SERVICE BULLETIN

Change of measurement method from cylinder head temperature to coolant temperature for ROTAX® Engine Type 912 and 914 (Series)

ATA System: 75-00-00 Cool system

MANDATORY

Fig. 1

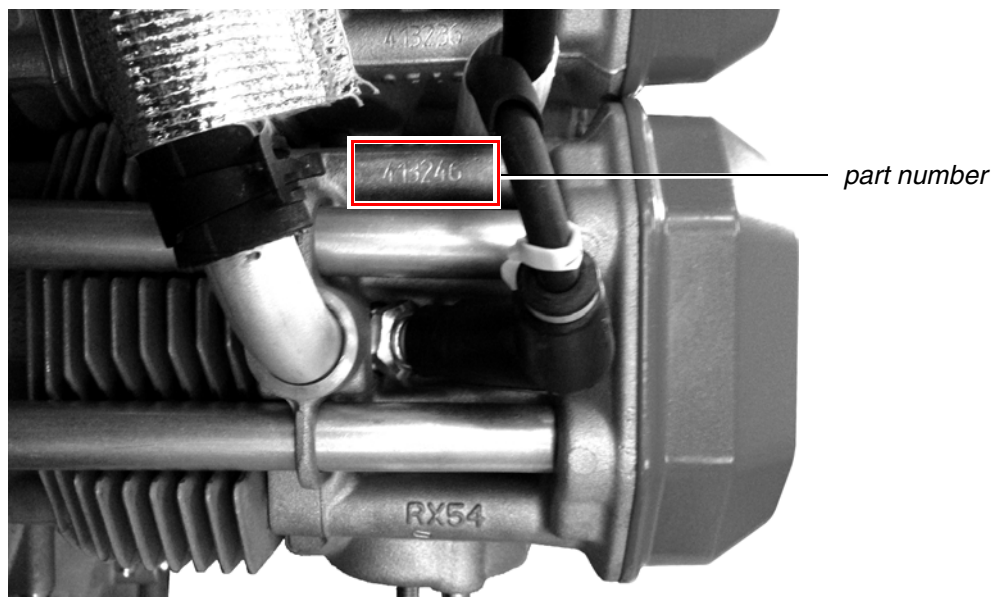
Step	Procedure
1	Check the engine serial number S/N, if the aircraft is affected by this SB.
2	Check of maintenance documentation if a repair or maintenance was performed on one of the cylinder heads.
3	Check the part numbers of the cylinder heads. See Fig. 1.
4	Check of the cockpit (indicating instruments) or the aircraft-specific manuals or consultation with the aircraft manufacturer or its service facilities if the coolant temperature or cylinder head temperature is displayed.
5	The measurement position naming in the indicating instrument or the operating limit must be amended or corrected in consultation with the aircraft manufacturer, if necessary. See section 3.1.1)

Fig. 2

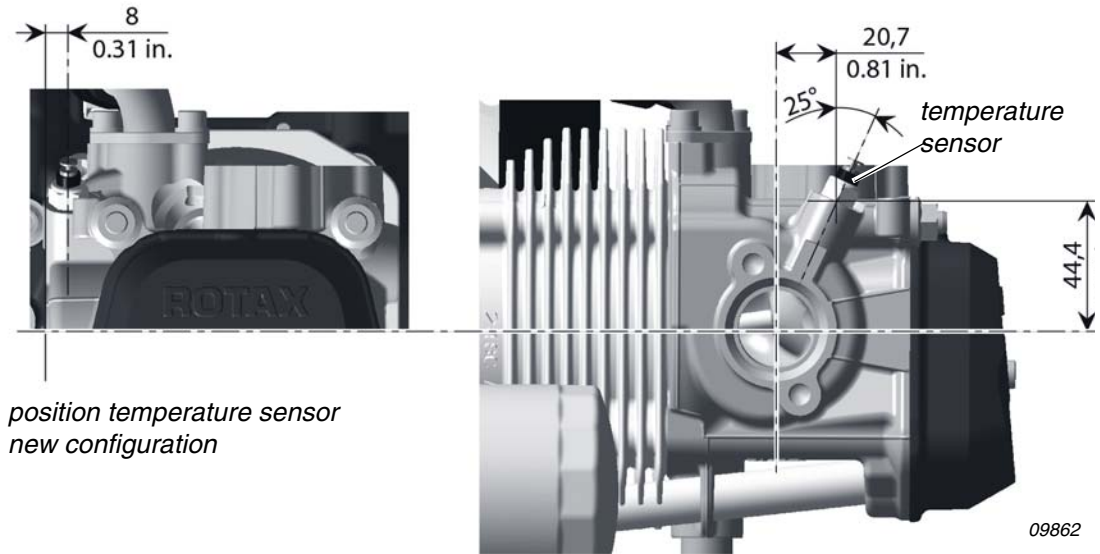
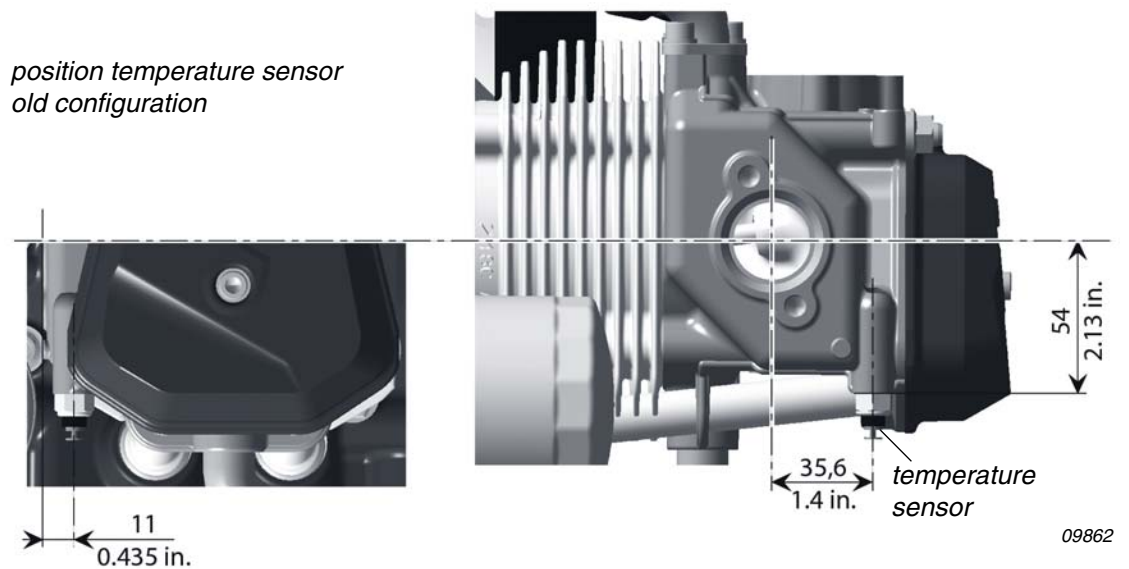
NOTE: Identifying of new cylinder heads: The electrical connection of the temperature sensor is pointing upwards. New configuration see [Fig. 2](#). Old configuration see [Fig. 3](#).

Regarding change of temperature sensor position, see Fig. 2 and Fig. 3.

It is NOT mandatory to retrofit engines with the old cylinder heads. The different versions of the cylinder heads can be mixed installed, but make sure, if and at which position the cylinder head temperature and coolant temperature is measured. This also defines the naming of the indicating instrument with the appropriate temperature limit.

Coolant temperature limit for measuring point in the cylinder head (new configuration)	Engine type
maximum 120 °C (248 °F)	912 A/F/S
	914 F
Permanent monitoring of coolant temperature is necessary
